Environmental Impact Assessment

Screening according to Schedule III of S.L. 549.46

ERA Reference no.:	EA 00017/23
PA Reference no.:	PA 03117/23 & PA 04143/23
Project Title:	Demolition of existing property, excavation of a plot, and proposed construction of 240 garages, at the basement levels. Proposed construction of 2 shop class 4B and construction of 197 apartments, including 17 apartments at receded floor level. The proposal includes pools at different levels. & Proposed demolition of existing building and excavation of 2 basement levels as per proposed plans. Phase 2 is to be covered by TN/272843. (Proposed temporary wall surrounding the property).
Location:	Site at 21, 23, 25, 27, 29, 31, Triq it-Torri, Trejqa ta' Boxbox, Msida
Screening date:	23 November 2023

Figure 3: Elevations of the proposed development. Source: *E-Apps PA 03117/23 Doc 10s*.

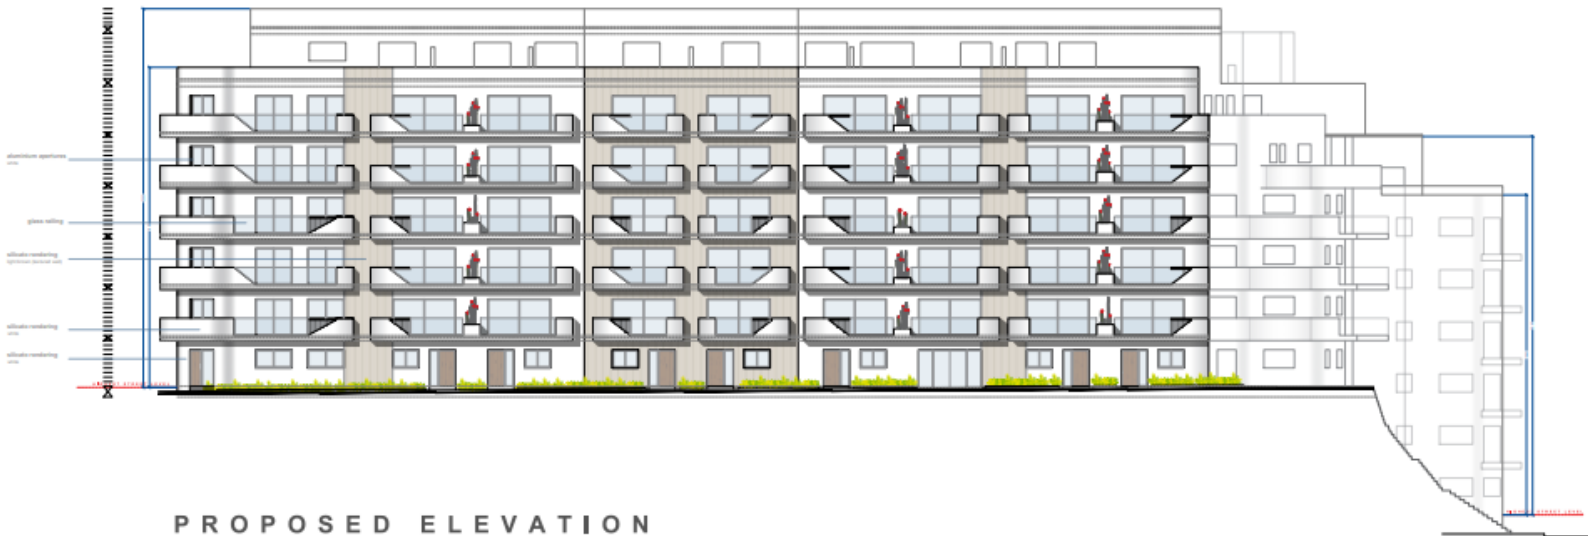
- 6.3 Due to the proposed increase in elevation within the site, the proposal is envisaged to have an adverse visual impact on the surrounding environment. Since the site lies within the development zone, adherence to the relevant planning policies vis-à-vis building design and façade details (colour, receding building lines etc.) is to be ensured and the necessary follow up be made by the competent authority i.e. Planning Authority.
